# **Review of: Modifications to Western Coal Services and Angus Place Colliery Modification report for modifications MP 06\_0021 (MOD 8) and SSD-5579 (MOD 5)**

**12 October 2023**

**Prepared by Dr Ian A. Wright**

**Figure 1. Water quality of Lake Lyell (Coxs River, near Lithgow). Salinity is represented by 'conductivity' and is in units  $\mu\text{S}/\text{cm}$ . Source: NSW EPA (Ref: GIPA EPA 724)**

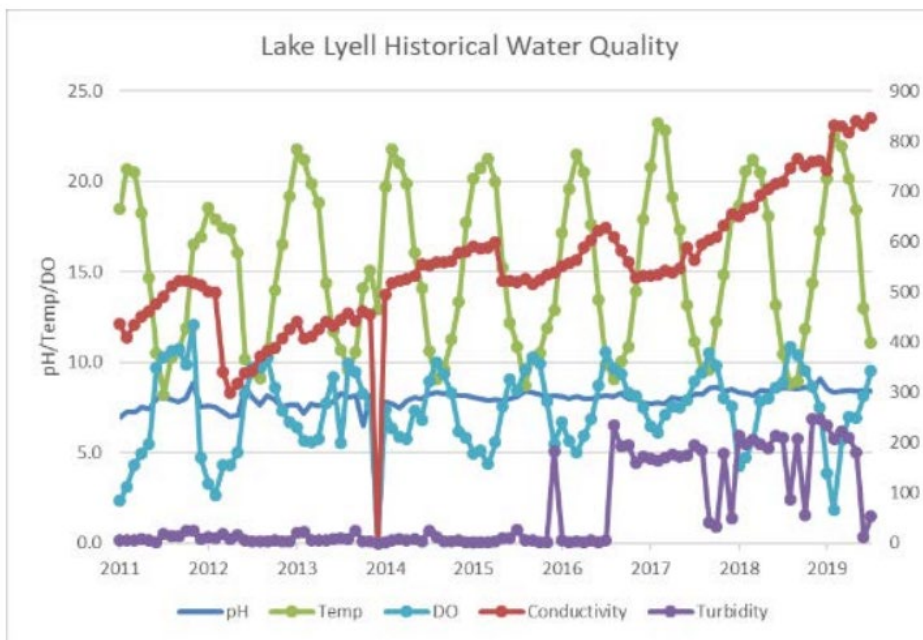
10. Based on the salinity calculations I have made, I have formed the opinion that the proposed transfer of mine water will cause an increased load of salt from LDP001 that is likely to contribute to elevated salinity downstream in Coxs River, where salinity has been increasing for about a decade.

11. Detailed time series data for salinity in Coxs River is available for Lake Wallace and Lake Lyell. Both lakes are located on the Coxs River. Lake Wallace is about 8km downstream of LDP001 and Lake Lyell a further 8 km downstream. The two graphs of water quality (above) were supplied by NSW EPA (Ref: GIPA EPA 724).

12. Salinity in Lake Wallace increased steadily over the period 2012 to 2019 from about 200  $\mu\text{S}/\text{cm}$  (in 2012) to more than 1200  $\mu\text{S}/\text{cm}$  (in 2019). Salinity in Lake Lyell also increased steadily over the period 2012 to 2019 from about 300  $\mu\text{S}/\text{cm}$  (in 2012) to more than 800  $\mu\text{S}/\text{cm}$  (in 2019). These salinity levels exceed the recommended guidelines for protection of aquatic ecosystems of less than 350  $\mu\text{S}/\text{cm}$  (ANZECC, 2000, 3.3. Physical and chemical stressors, Table 3.3.3).

**Figure 3. Salinity (as ‘Conductivity’) at six sampling sites within Lake Burragorang (Sydney’s main drinking water supply impounded behind Warragamba d). Salinity is represented by ‘conductivity’ and is in units mS/cm. Source: Sydney Drinking Water Catchment Audit 2019 – Volume 3**

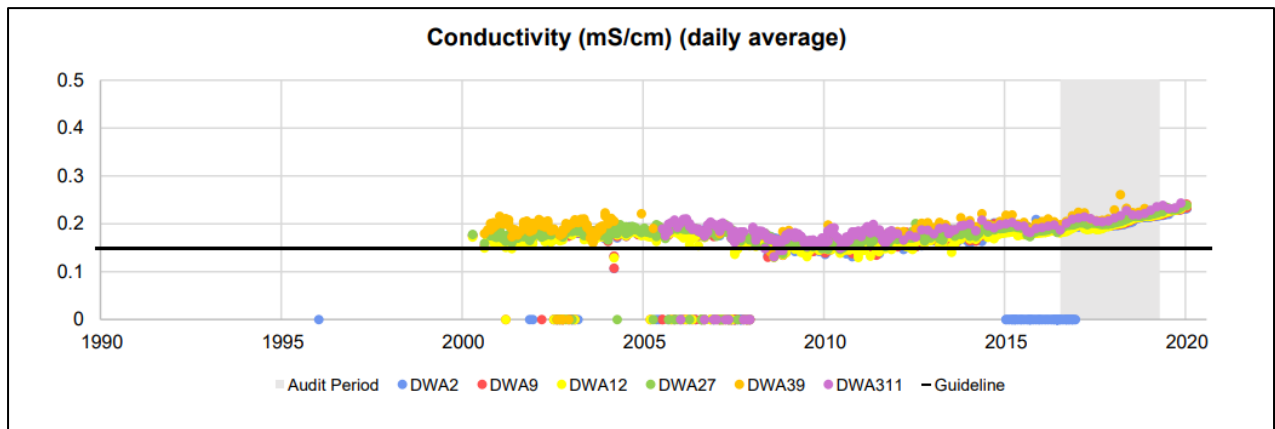
14. I have also formed the opinion that an increased load of salt from LDP001 is likely to contribute to elevated salinity downstream within Lake Burragorang/Warragamba Dam. Coxs River is the second largest river supplying water into Lake Burragorang/Warragamba Dam. The 2019 Sydney Drinking Water Catchment Audit Report shows that salinity at several sampling sites located within Warragamba Dam (DWA2, DWA9, DWA12, DWA27, DWA39, DWA311) display a rising trend from 2010 to 2019 (Sydney Drinking Water Catchment Audit 2019 – Volume 3).

15. The graph below (Figure 3) was extracted from the Sydney Drinking Water Catchment Audit 2019 – Volume 3. Please note that the units of electrical conductivity used in this graph (mS/cm) are different to others used in ANZECC and previously in this report. For comparison, 0.2 mS/cm is equivalent to 200  $\mu\text{S}/\text{cm}$ .

I have formed the opinion that the transfer of mine water from Angus Place will contribute wastewater of higher salinity, above ANZECC guidelines, downstream to the Coxs River and contribute to salinity in Warragamba Dam.
